ITEM #3.0

PRELIMINARY & FINAL PLAT APPROVAL:

Sendero Phase I Subdivision
Being a resubdivision of 51.376-acre tract
of land out of the south end of Porcion 52
PUD (R-1)
Developer: Rhodes Development, Inc.
Engineer: Melden & Hunt, Inc.

REVIEW DATA

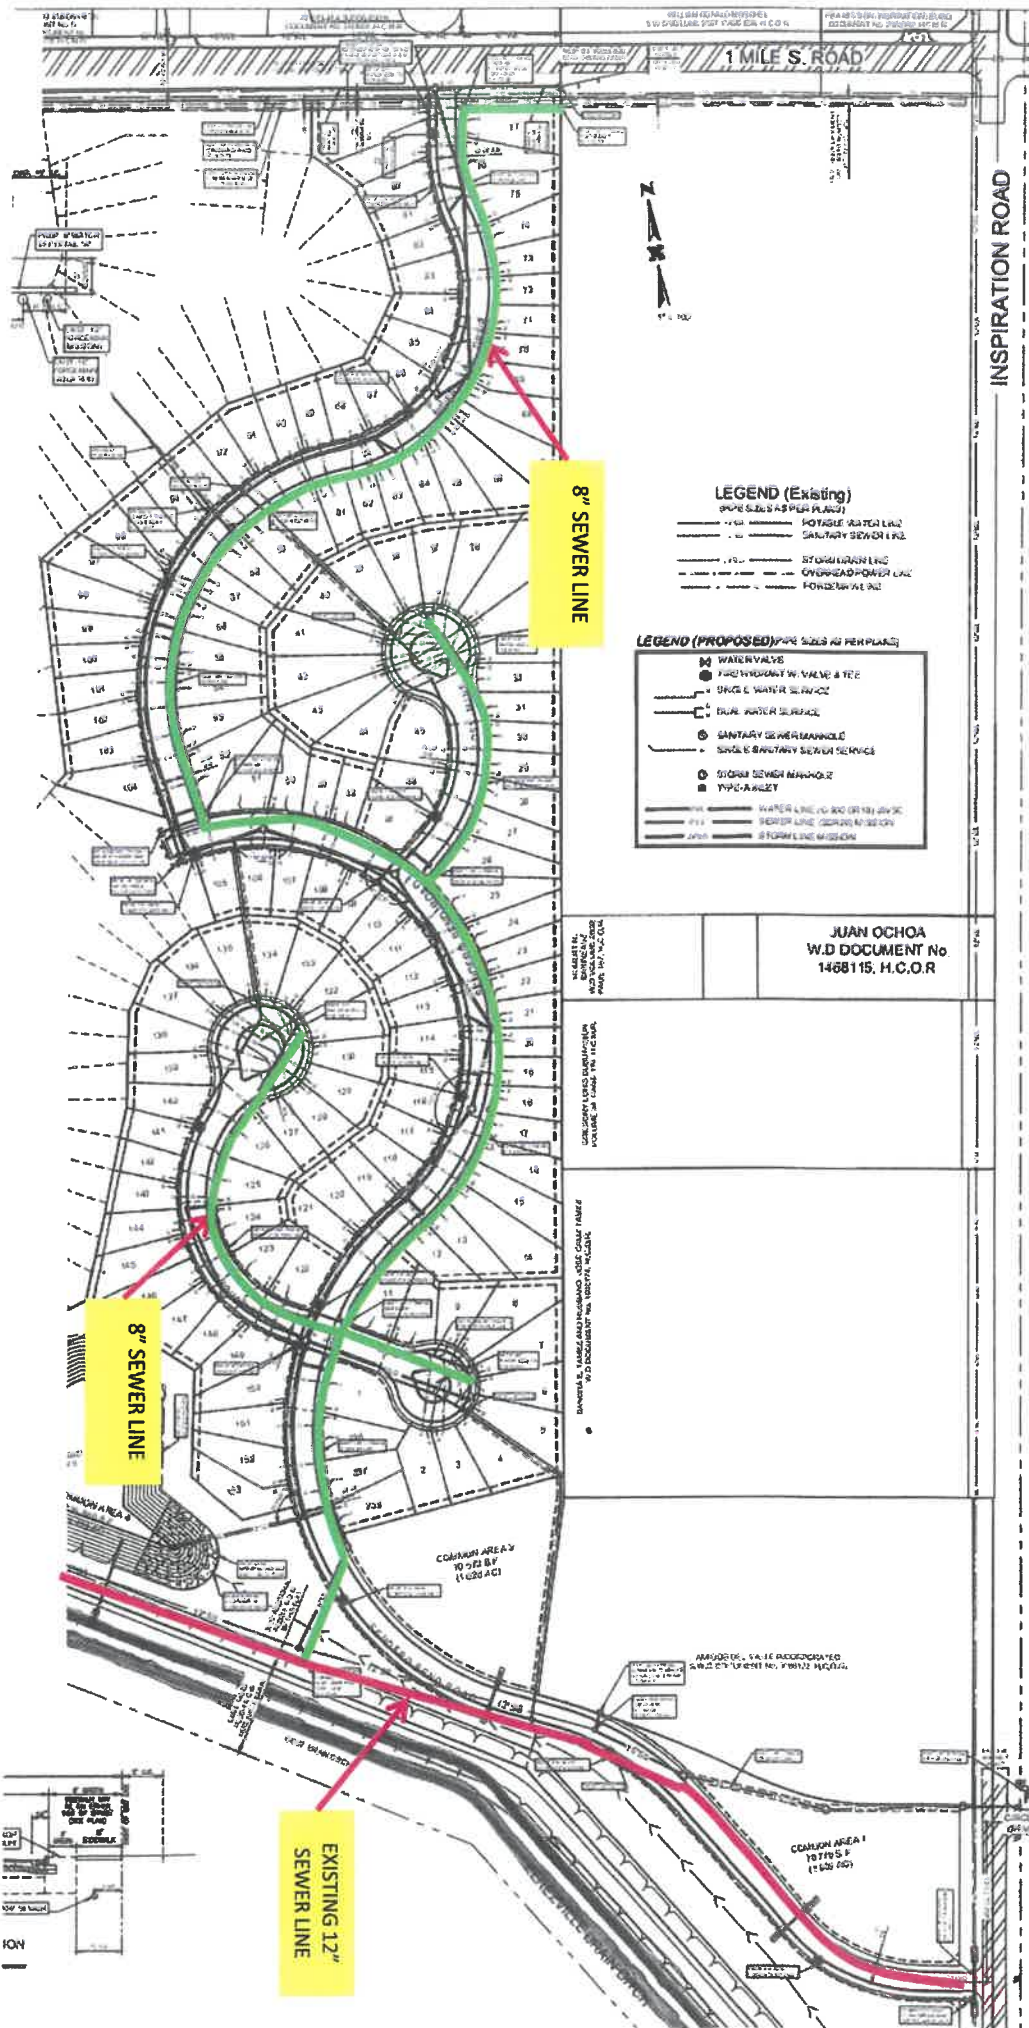
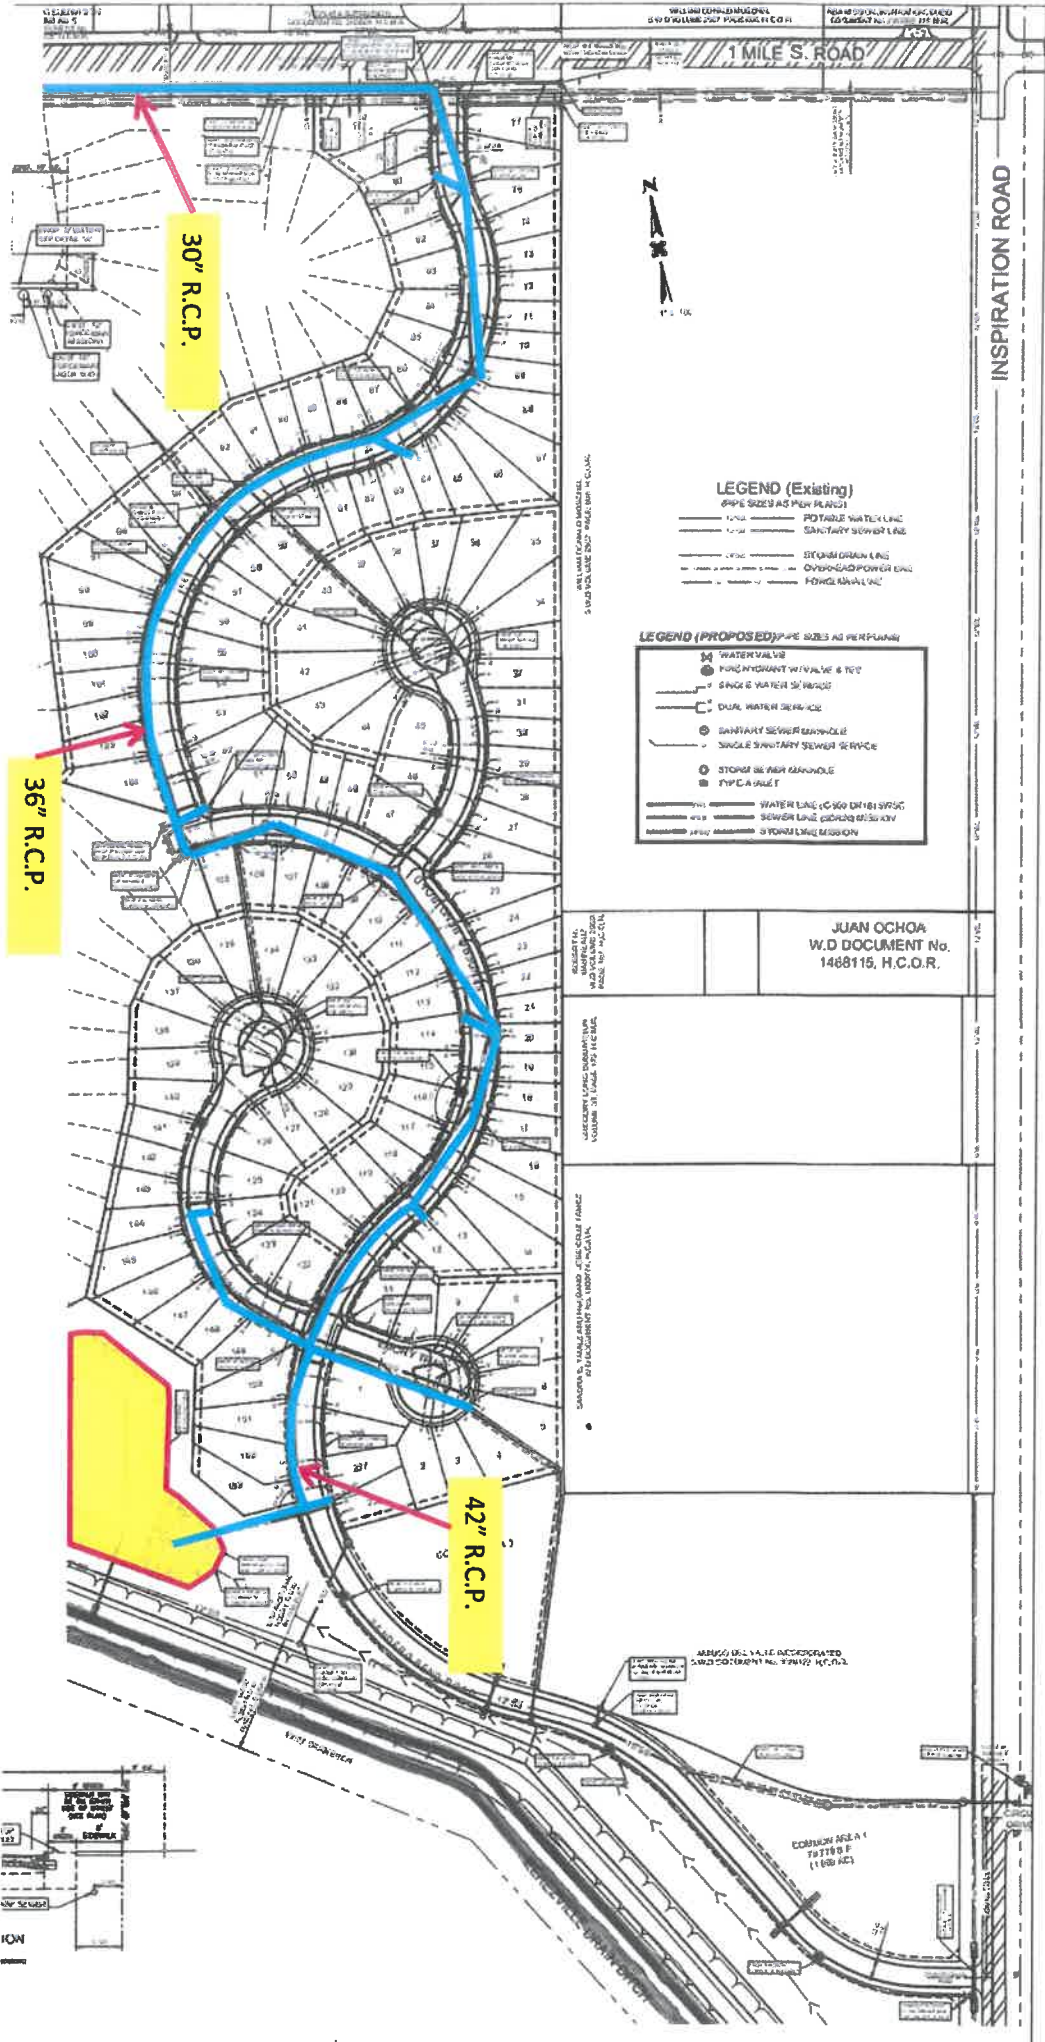
The developer is proposing to connect to an existing 12" water line located along the south R.O.W. of Mile One South Rd. and extend an 8" water line through the subdivision providing a 2" water service to each lot. There are 11 proposed fire hydrants via direction of the Fire Marshal's office. – **see utility plan**

The developer is proposing to connect to an existing manhole within the R.O.W. at the southern access of the development and extend a 12" line west along the north side of the Perezville Ditch. A proposed 8" Sanitary Sewer line will run through the subdivision and collect from each lot through a 4" front and center stub out service. The Capital Sewer Recovery Fee is required at \$200.00/Lot which equates to \$30,600.00 (\$200 x 156 Lots).

1. Payment of Capital Sewer Recovery Fees
2. Provide Water District Exclusion
3. Comply with all other format findings
